July 14, 2005

RE: FERC Project No. 2079 - CA
Middle Fork American River Project
LL Anderson Dam PMF Study Supplement

**Supplement to the June 2003
Probable Maximum Flood Study
L.L. Anderson Dam
FERC Project No. 2079**

Exhibit 1: PMF wind pattern based on maximum recorded Hell Hole sequence

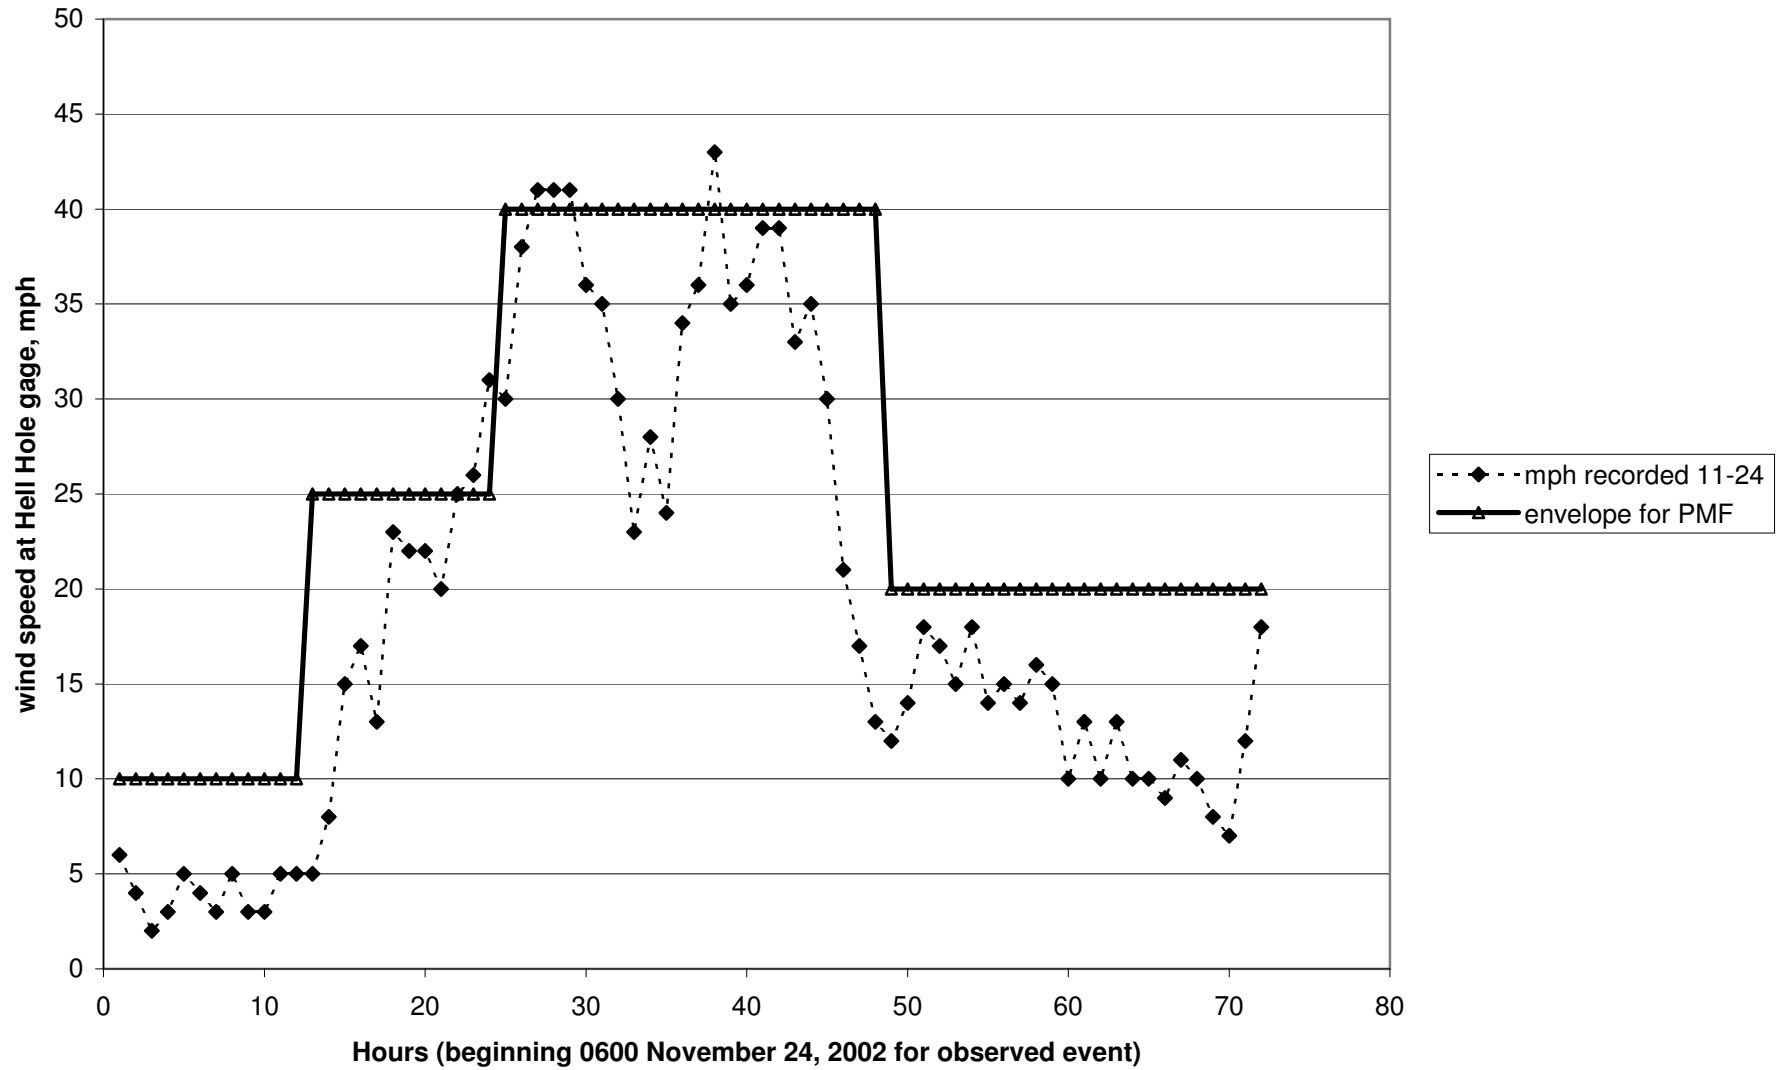
An envelope wind speed sequence was then constructed around the November 2002 wind data (Exhibit 1). This envelope sequence, including a 24-hour period of 40-mph wind speeds, was entered into the HEC-1 model. The Hell Hole winds were not adjusted further for basin elevation, as the wind recorder is situated on an exposed ridge that would experience exceptionally high winds relative to the basin as a whole.

Exhibit 2: Flood hydrographs

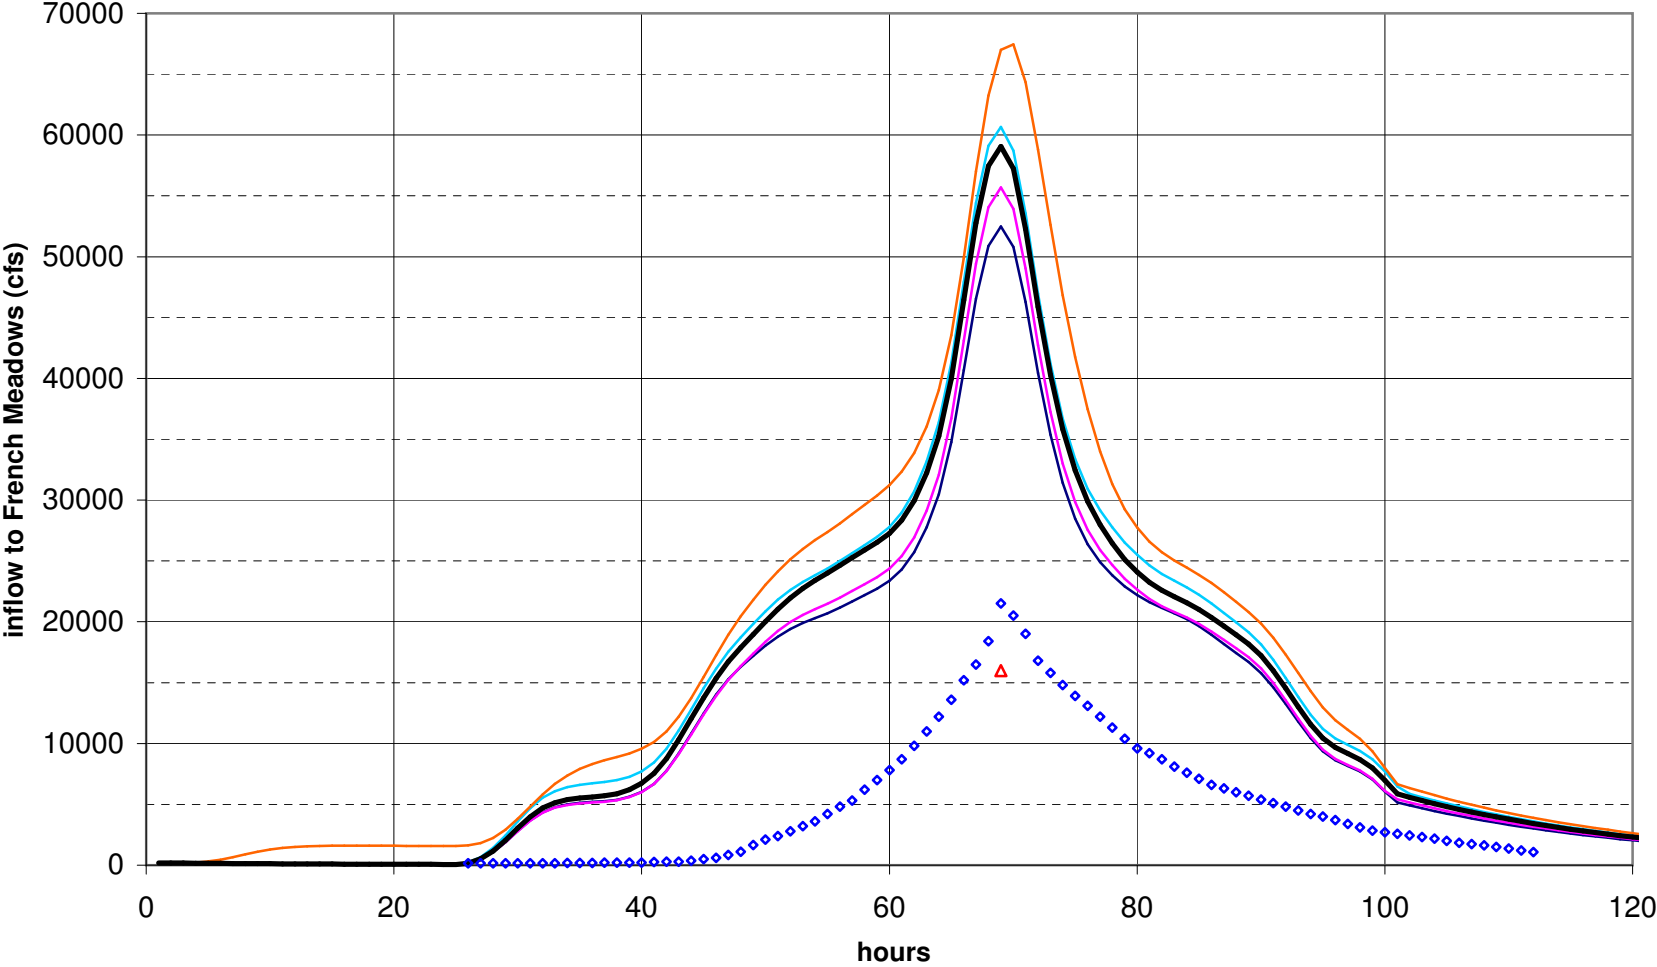
The PMF inflow hydrographs associated with the entries in Table 1 are shown in Exhibit 2. Also shown is an estimate, based on the recorded peak flow and daily average flows, of the flood of record. The flood of record occurred in December 1963, before the dam was completed, and peaked at 21,500 cfs. The estimated peak inflow in the 1997 flood, 16,000 cfs, is also shown for comparison.

As a result of these analyses, we recommend that the adopted PMF hydrograph be the one generated from the HEC-1 energy budget snowmelt method, using the maximum Hell Hole wind speed envelope. This hydrograph, which peaks at 59,100 cfs, reflects extremely severe precipitation and temperatures. The wind sequence is also a very rare one and would be extremely unlikely to occur simultaneously with the PMS. It is not, however, as extraordinary as the sequence provided by HMR 58, which includes a 1-hour wind that is one-and-a-half-times larger than the maximum observed at the Hell Hole station. Our recommended set of assumptions also does not include the additional conservatism of a “primed” snowpack. The hourly ordinates of the PMF inflow hydrograph are attached as Exhibit 3.
